**PLANNING COMMISSION SITE PLAN
CONDITIONAL USE PERMIT REVIEW SHEET**

CASE NUMBER: SPC-2015-0322C **PLANNING COMMISSION:** May 24, 2016

PROJECT NAME: Montopolis Water Reclamation Storage Reservoir/Pump Station

CITY OF AUSTIN – PLANNING AND DEVELOPMENT REVIEW DEPARTMENT
SITE PLAN APPLICATION – MASTER COMMENT REPORT

CH2MHILL®
ARCHITECTURAL
ELEVATIONS

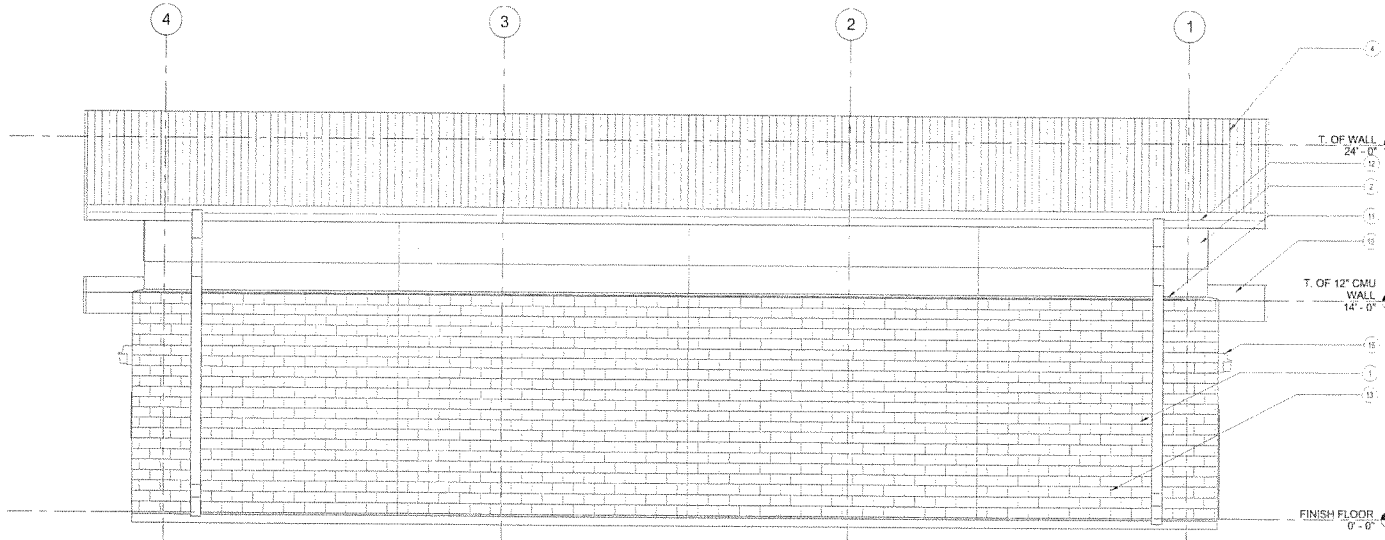
SP 11. Provide elevational views of the pump building and the reservoir.

Update # 1. Please add labels that identify what they are.

Update # 2. Call out elevations as “Pump Building” or “Reservoir”.

Update # 3. Height still needs to be shown on the reservoir elevation since there is no scale.
